Re: Morton-Holton Lakes Pit Substitute Water Supply Plan (WDID 0202616)

Morton-Holton Lakes Mine DRMS File No. M-2008-082 (WDID 0203053)

SWSP ID: 5178

Approval Period: January 1, 2024 through December 31, 2024

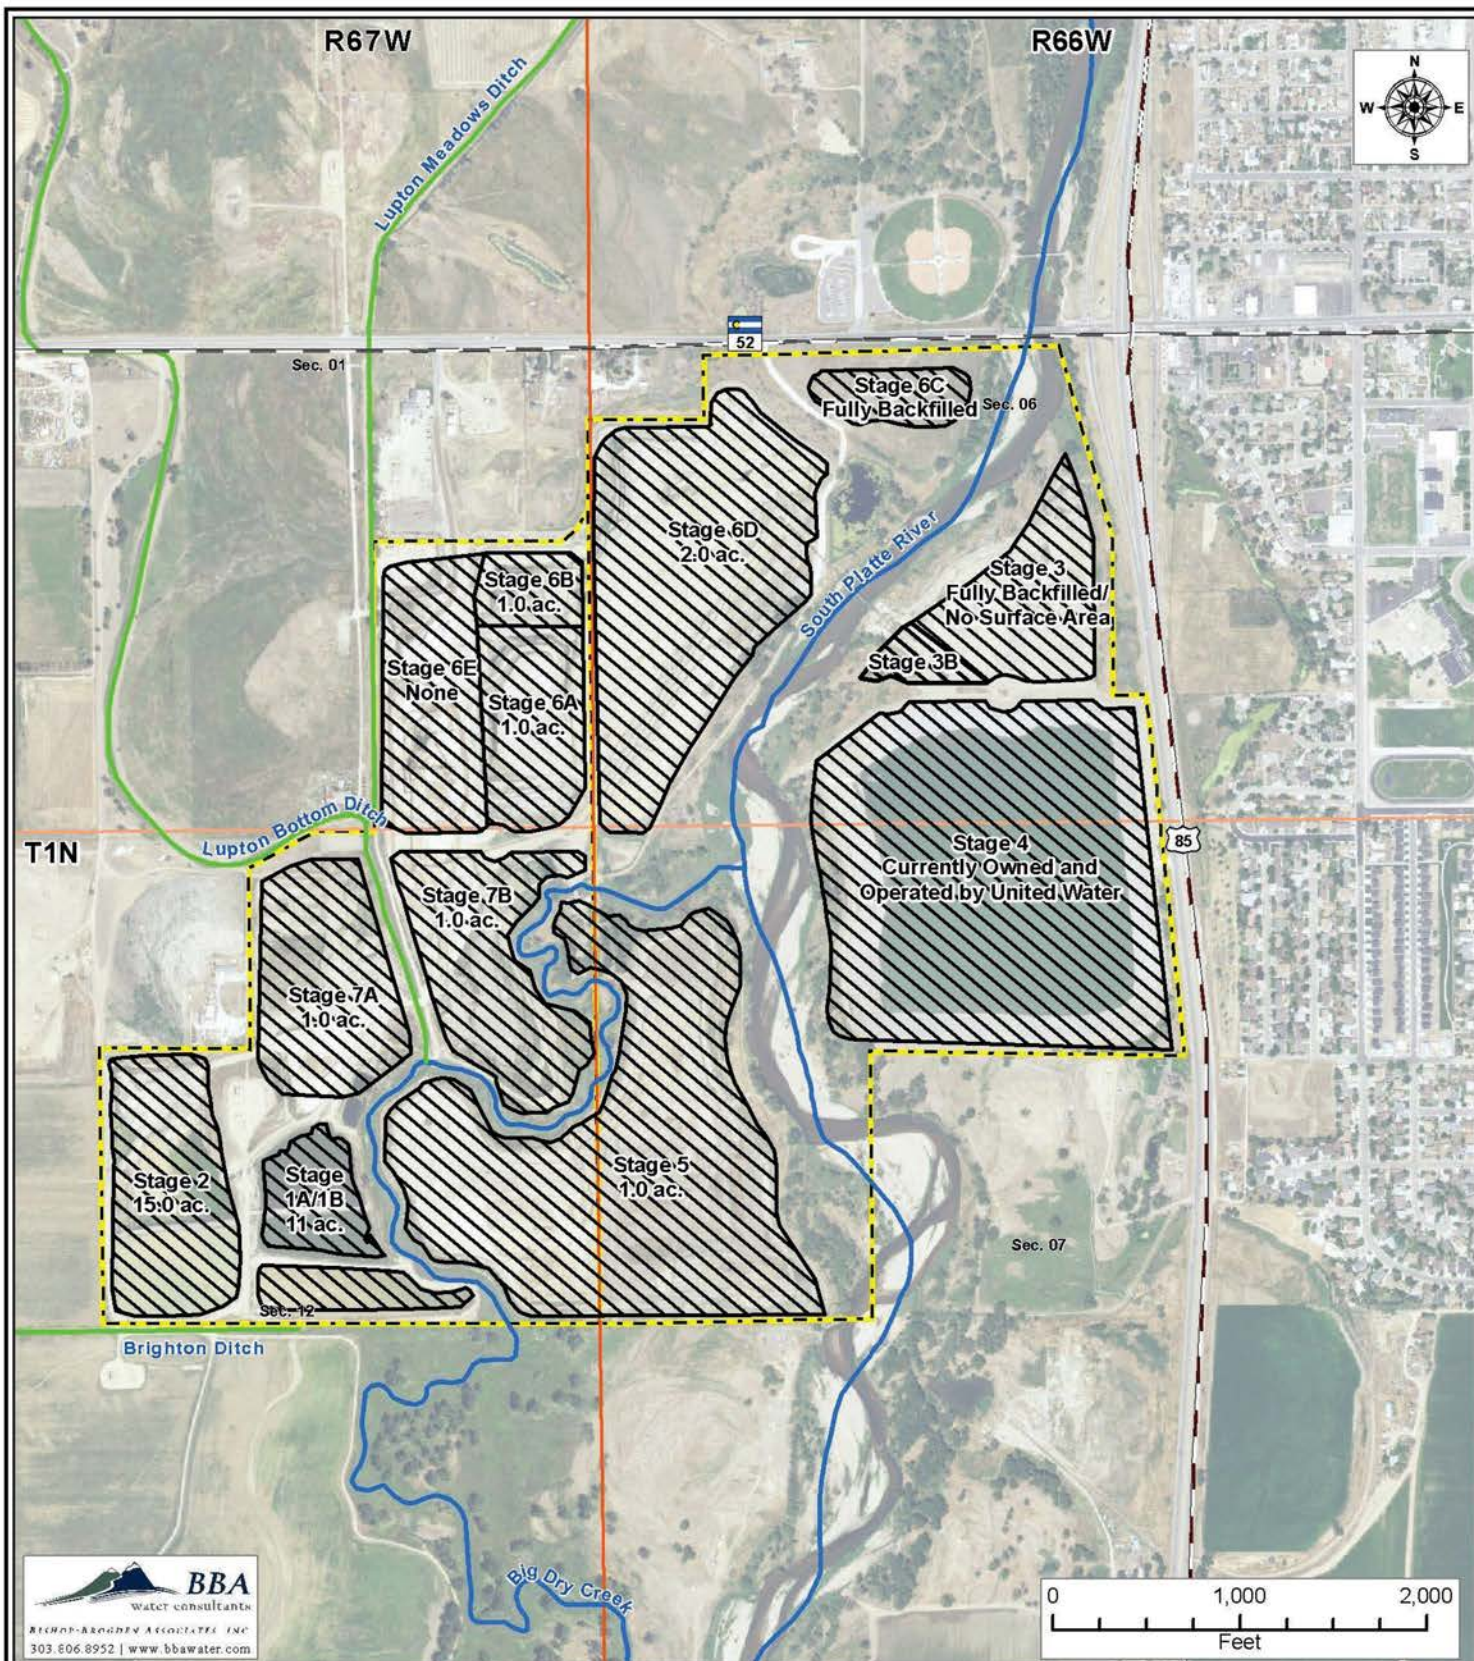
Mining of the Morton Lakes site is presently expected/projected to last until at least 2026. The current mining plan for the site is shown in attached Figure 1. The mining status of the Stages is described below and on attached Table B:
